UNITED STATES PATENT AND TRADEMARK OFFICE

APPLICATION NO.	FILING DATE	FIRST NAMED INVENTOR	ATTORNEY DOCKET NO.	CONFIRMATION NO.
10/707,664	12/31/2003	Ivan Yang-En Wu	7635-US-PA	1663

Office Action Summary	Application No.	Applicant(s)	
	10/707,664	WU ET AL.	
	Examiner	Art Unit	
	Tarifur R. Chowdhury	2871

DETAILED ACTION

FIG. 3

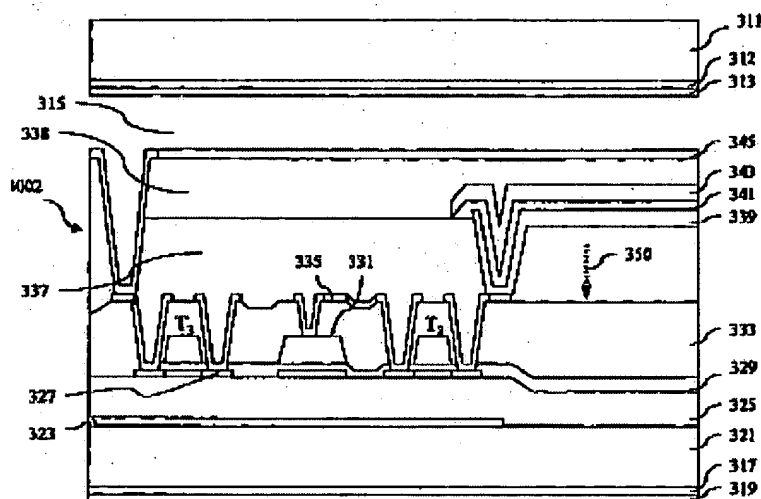
7. Wang discloses and shows in Fig. 3, a dual mode liquid crystal display device (abstract), comprising:

- a lower substrate (311);
- an upper substrate (321) having a first thin film transistor (T3) and a first transparent electrode (345) electrically connected to the first thin film transistor, a second thin film transistor (T2) and a regional light-emitting source (combination of layers 339, 341 and 343) electrically connected with the second thin film transistor; and
- a liquid crystal layer (315) between the upper substrate and the lower substrate.

Accordingly, claims 9 and 10 are anticipated.

As to claims 15 and 16, numeral (339) is considered as a first transparent electrode and a regional light source (combination of layers 341 and 343) electrically connected to the first transparent electrode.

15. As to claims 11 and 17, Wang discloses and shows in Fig. 3 that the light-emitting diode further includes:

- a light-emitting layer (341) on a surface of the electrode (339); and
- a cathode (343) on the light-emitting layer facing the lower substrate.

Wang differs from the claimed invention because he does not explicitly disclose that a portion of the first transparent electrode serves as an anode for the light-emitting diode. However, it is common and known in the art to eliminate extra layers and thus obtain a device that is thin and light weight. Therefore, it would have been obvious to one of ordinary skill in the art at the time of the invention was made to modify the display device of Wang by eliminating the layer (345) and extending the anode (339) so that it is also connected to the first thin film transistor (T3) and working as the first transparent electrode (pixel electrode) to obtain a display device that is thin and light-weight.

As to claims 12 and 18, Wang further shows in Fig. 3 that the upper substrate further includes a quarter-wave plate (317) on one surface of the substrate (321) and a polarizer plate (319) on the quarter-wave plate.

FIG. 1

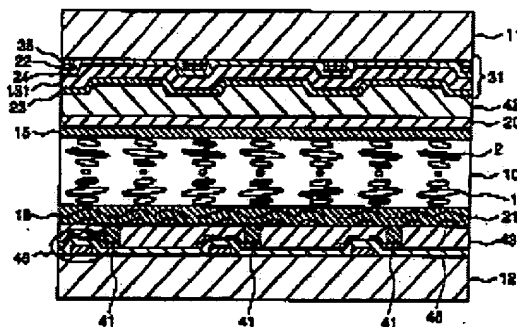
9. Itou discloses and shows in Fig. 1, a dual mode liquid crystal display device, comprising:

- an upper substrate (11) having a first transparent electrode (23) and a regional light source (combination of layers 131, 24, 22, 35) electrically connected to the first transparent electrode;
- a lower substrate (12) having a second electrode (21); and
- a liquid crystal layer (10) between the upper substrate and the lower substrate.

Accordingly, claims 15 and 16 are anticipated.

As to claim 17, it is clear from Fig. 1 and the disclosure of Itou that the first transparent electrode (23) serve as an anode for the light-emitting diode and the light-emitting diode further includes:

- a light-emitting layer (131) on a surface of the first transparent electrode facing the lower substrate (12); and

- a cathode (22) on the light-emitting layer facing the lower substrate.

FIG. 4

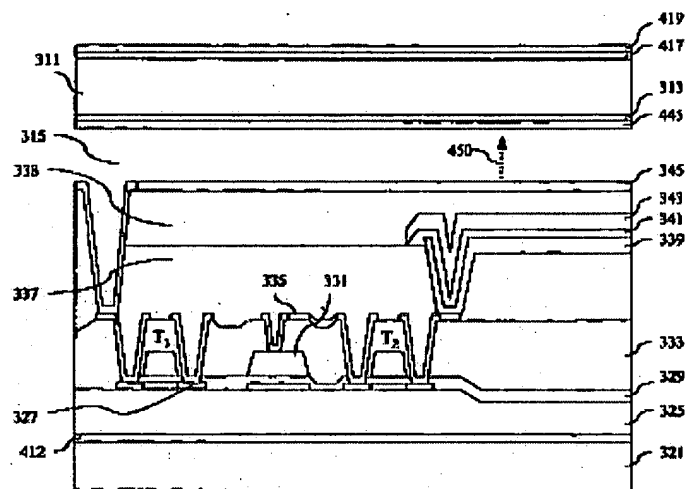
13. Wang discloses and shows in Fig. 4, a dual mode liquid crystal display device, comprising:

- an upper substrate;
- a lower substrate (321) comprising a first thin film transistor (T3), a second thin film transistor (T2), an electrode (345) connected to the first thin film

- transistor (T3), and a regional light-emitting source (combination of layers 339, 341 and 343) connected to the second thin film transistor (T2); and
- a liquid crystal layer (315) between the upper substrate and the lower substrate.

Wang further shows that a reflective layer (412) is formed on the lower substrate (321).

Wang differs from the claimed invention because he does not explicitly disclose that the electrode layer (345) is reflective. However, it is common and known in the art to reduce extra layers and thus obtain a compact and thin device that is light weight and cheap to manufacture. Further, using a reflective electrode instead of a combination of a reflective layer and an electrode is also common and known. Therefore, it would have been obvious to one of ordinary skill in the art at the time of the invention was made to modify the display device of Wang by eliminating the reflective layer and using a reflective electrode instead of the electrode (345) in order to obtain a compact device that is thin and light weight.

Accordingly, claims 1 and 4 would have been obvious.

As to claims 2 and 3, Wang also shows in Fig. 4 that the upper substrate of the display device further includes:

- a substrate (311);
- a color-filtering array (313) on one surface of the substrate; and
- a first transparent electrode (445) on the surface of the color-filtering layer;
- a polarizer plate (419) and
- a quarter-wave plate (417) on a substrate surface just opposite the color-filtering array.

As to claim 5, Wang also discloses and shows in Fig. 4 that the light-emitting diode further includes:

- a cathode (343) on the lower substrate;
- a light-emitting layer (341) on the cathode; and

- a second transparent electrode (339) on the light-emitting layer , wherein the second electrode serves as an anode.

As to claim 6, it is clear from Fig. 4 of Wang that the electrode (445) is set up on a layer (338) (applicant's bumpy layer).

As to claims 7 and 8, it is also clear from the disclosure as well as Fig. 4 of Wang that the first thin film transistor (T3) and the electrode (445), the second thin film transistor (T2) and the regional light-emitting source are formed in a pixel region.
